## Groundwater Application Review Summary Form

Application # G- 18554

TO: Water Rights Section Date 11/21/17  
 FROM: Groundwater Section Benjamin Scandella, Dennis Orlowski  
Reviewer's Name  
 SUBJECT: Application G-18554 Supersedes review of \_\_\_\_\_  
Date of Review(s)

A. **GENERAL INFORMATION:** Applicant's Name: **BRYAN AND AMY SCHURTER** County: **MARION**

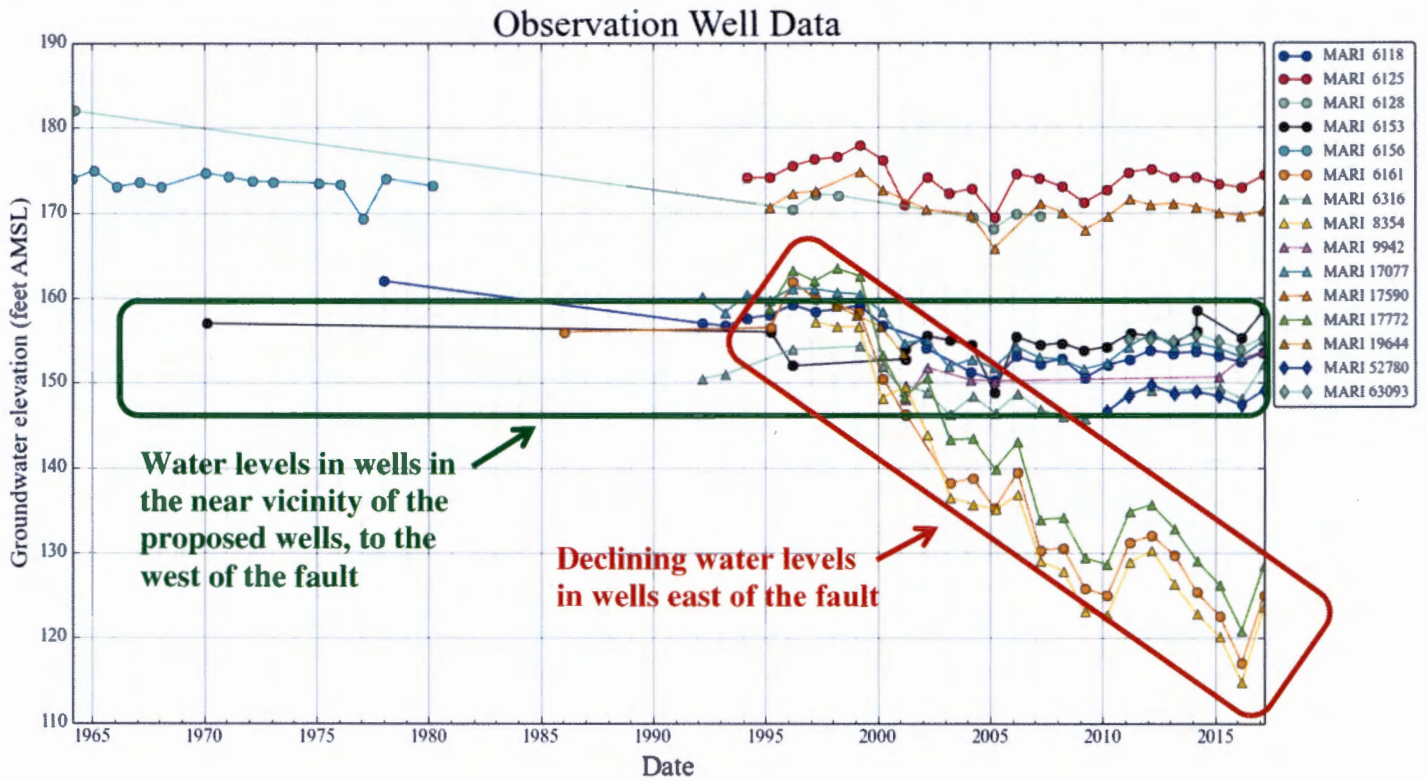
Evaluation of groundwater availability may be informed by water level data. Long term trends indicate relatively stable water levels in wells in the immediate area and on the west side of the north-northwest trending fault to the east of the proposed wells (e.g. MARI 6153 and 9942), with head losses limited to 10 feet since 1990 within the CRBG (Figure 2). Water levels in basalt wells to the northeast of the proposed well show declines typically ranging from 30 to 50 feet since 1990 (e.g. MARI 6161, MARI 8354, and MARI 17772, Figures 1 and 2), but their positioning on the east side of the fault suggests that this fault effectively isolates those eastern portions of the aquifer system from the western ones targeted by the applicant. These results suggest that the groundwater resources accessed by the wells in the lateral vicinity of the proposed wells are not over-appropriated. However, both the depth of the proposed wells and the well construction requirements indicate that the proposed wells may withdraw water from water-bearing zones beneath those accessed by the wells analyzed here, so the degree of over-appropriation in the actual target aquifer cannot be determined. The 7I decline condition, as stipulated by OAR 690-502-0250, should provide some protection for the resource and for senior users if declines become evident in the future.

**Basis for aquifer hydraulic connection evaluation:** Water levels in multiple wells on the same side of the nearest fault lie within the same range as the elevations of local incision by the Pudding River (e.g. MARI 6153, MARI 9942, MARI 52780, and MARI 63039, as seen in Figure 1), and the correspondence suggests that at least some of the water-bearing zones accessed by these wells are hydraulically connected with SW#3. Potential pathways that could enable this hydraulic connection include vertical conductivity along the regional fault network and through wells open to multiple water-bearing zones. The well construction requirements specified in section B should reduce the chances of establishing a hydraulic connection with surface waters by sealing off the well from the shallower water-bearing zones.

Figure 2: Well Location Map: blue triangles represent declines in water levels since 1990 for well with available data.

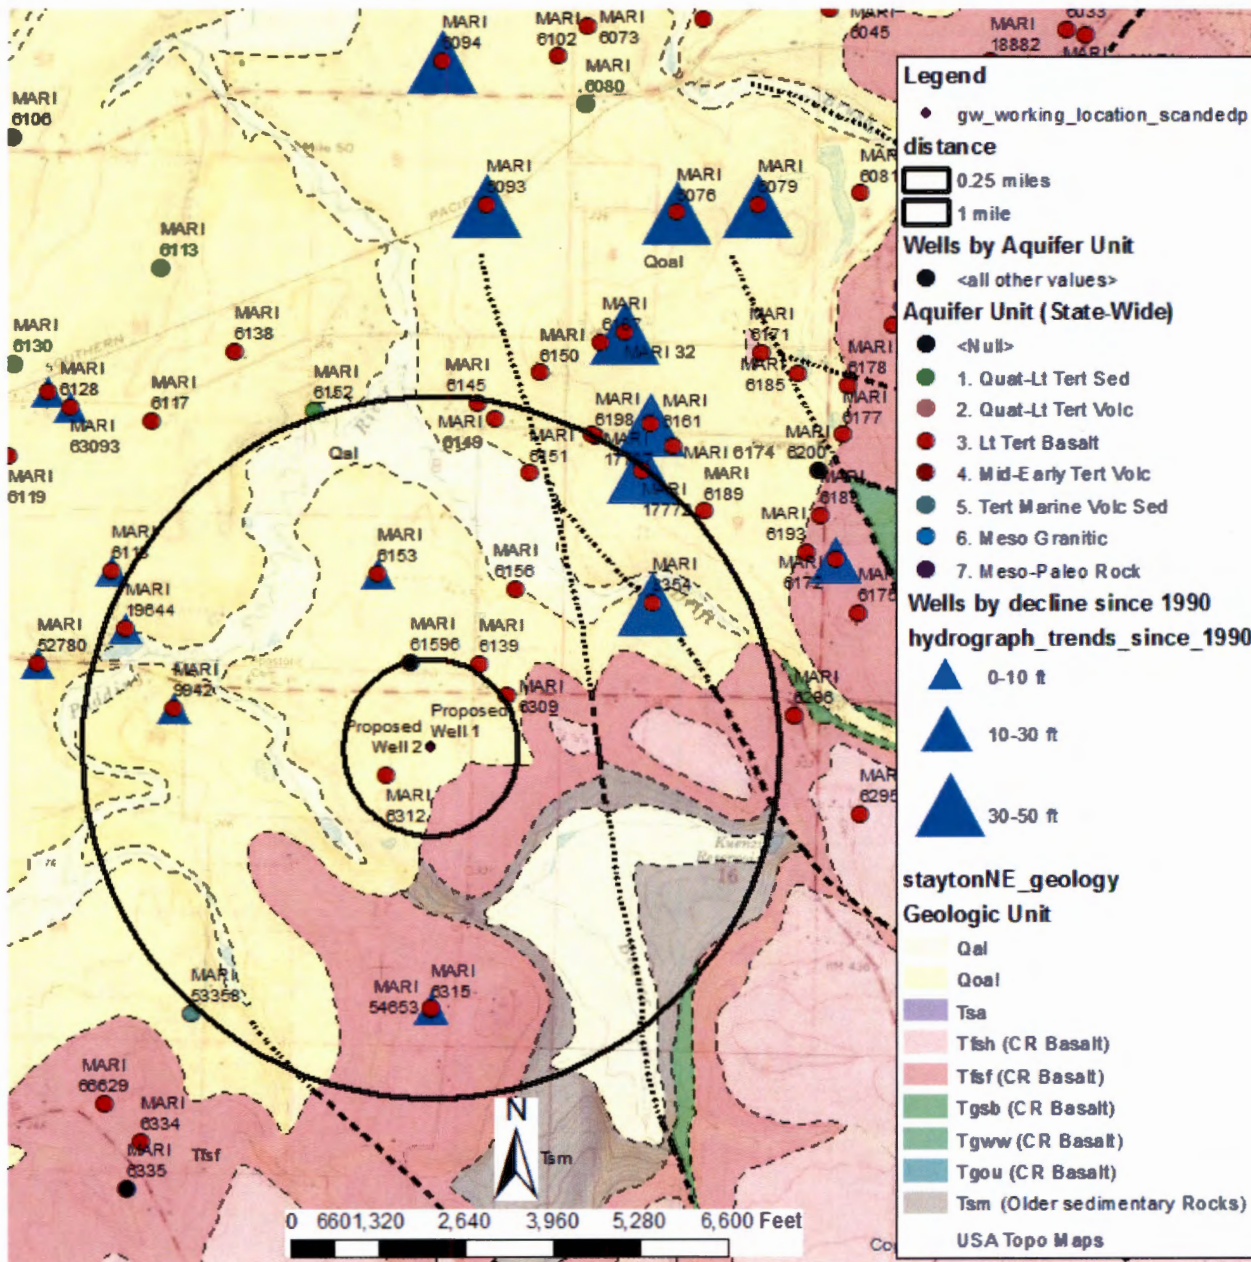
Multiple northwest-trending faults are mapped in the vicinity of this well (see map in Figure 2), and the vertical offset between CRBG flows along those faults may impact the extent and pumping response of the CRBG interflow zones. Vertical offset of CRBG flows can cause juxtaposition of permeable interflows with dense flow interiors, resulting in a low-or no-flow boundary at the fault trace. The resultant compartmentalization could buffer or delay well-to-well impacts, while also limiting the aquifer extent. Additionally, fault systems can promote hydraulic connection between separate interflow zones via sub-vertical fractures associated with the fault. At the subject site, the degree to which this fault impedes horizontal flow or enhances vertical flow of groundwater is uncertain.
